Form C-103
 Revised July 18, 2013

SUNDRY NOTICES AND REPORTS ON WELLS
 (DO NOT USE THIS FORM FOR PROPOSALS TO DRILL OR TO DEEPEN OR PLUG BACK TO A DIFFERENT RESERVOIR. USE "APPLICATION FOR PERMIT" (FORM C-101) FOR SUCH PROPOSALS.)

SEE ATTACHED COA-5

HANLEY PETROLEUM, INC
 State 32 #1, API # 30-015-29378
 Eddy Co, NM

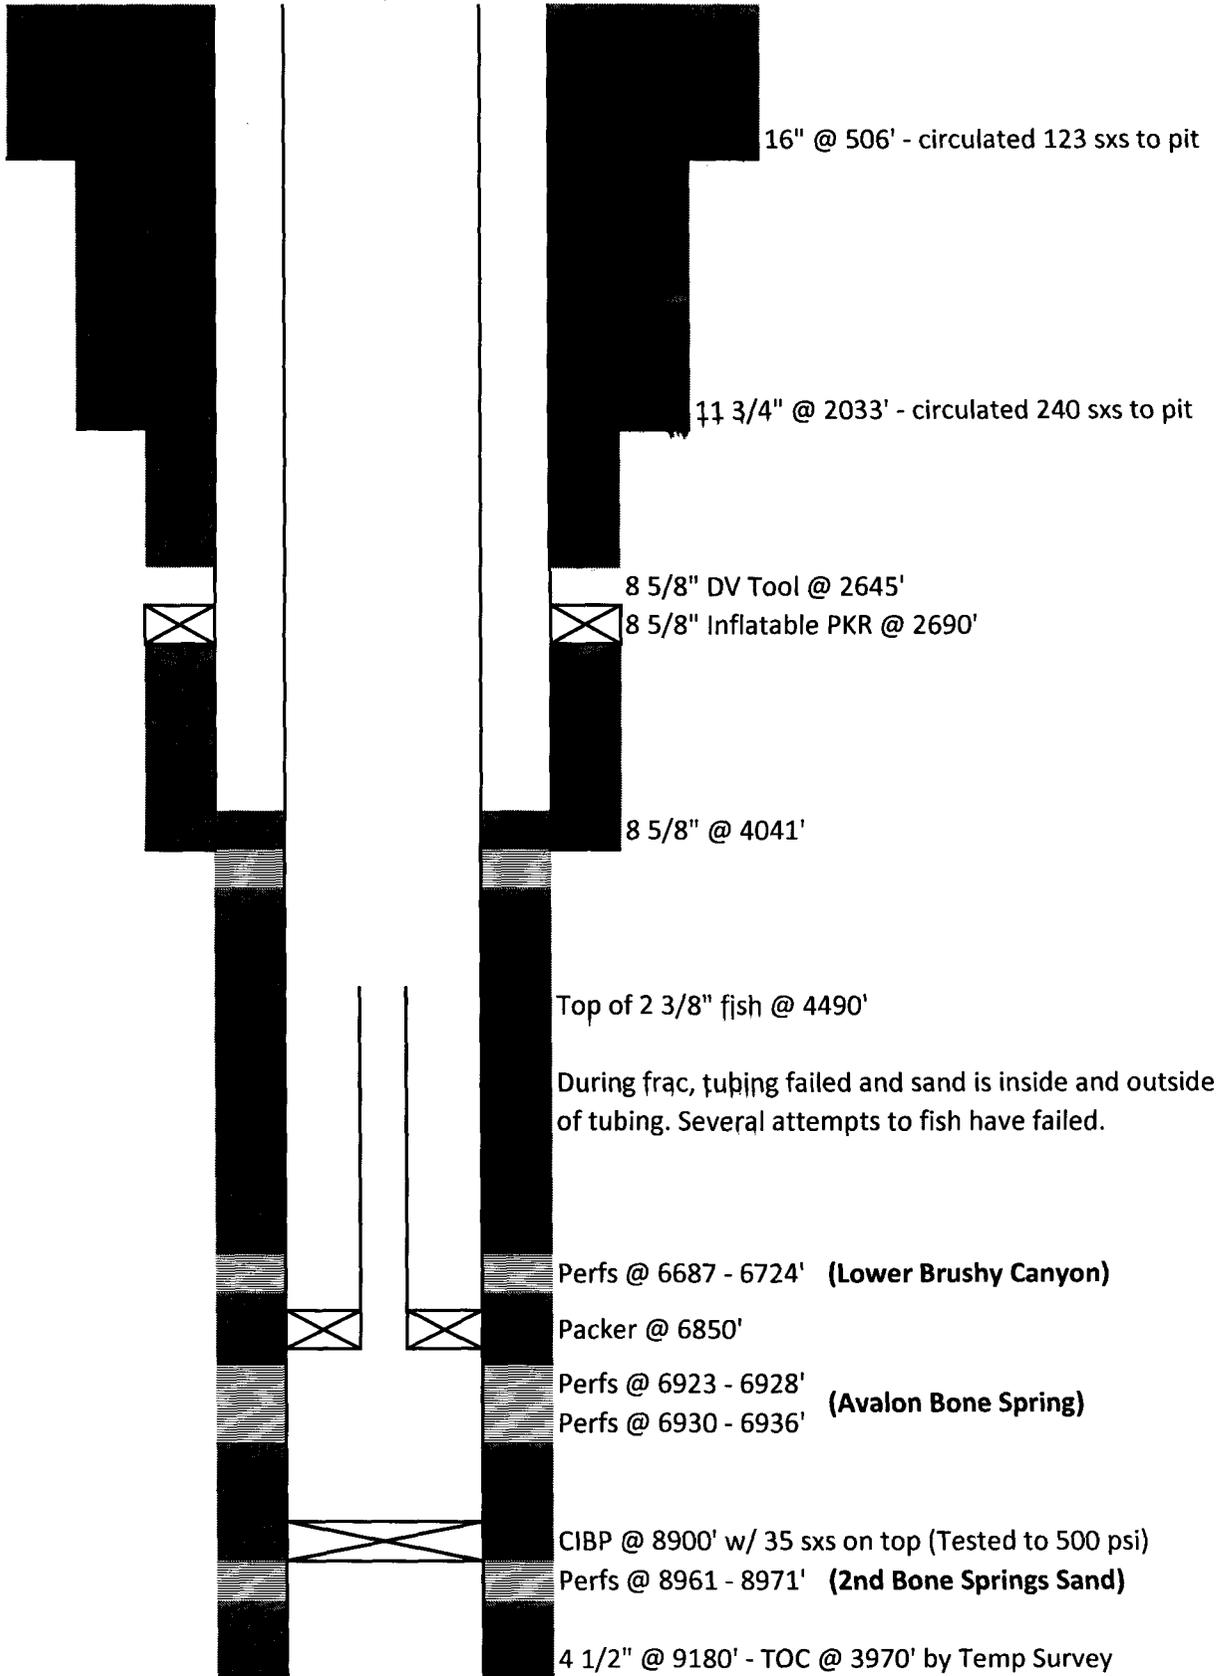
7) Spot 40 sxs from 556-456'
 PERF & SQUEEZE @ 556' - woe & TAG

6) Spot 40 sxs from 2083-1983'
 PERF & SQUEEZE @ 2083 - woe & TAG

← woe & TAG

4) Spot 40 sxs cement from 3900-3800' ← woe & TAG

2) Perf 4.5" @ 4,091', sqz/spot 25-50 sxs from 4100-3900' ← woe & TAG

1) CIBP @ 4480' w/ 35 sxs on top ← woe & TAG
 Top of 2 3/8" fish @ 4490'
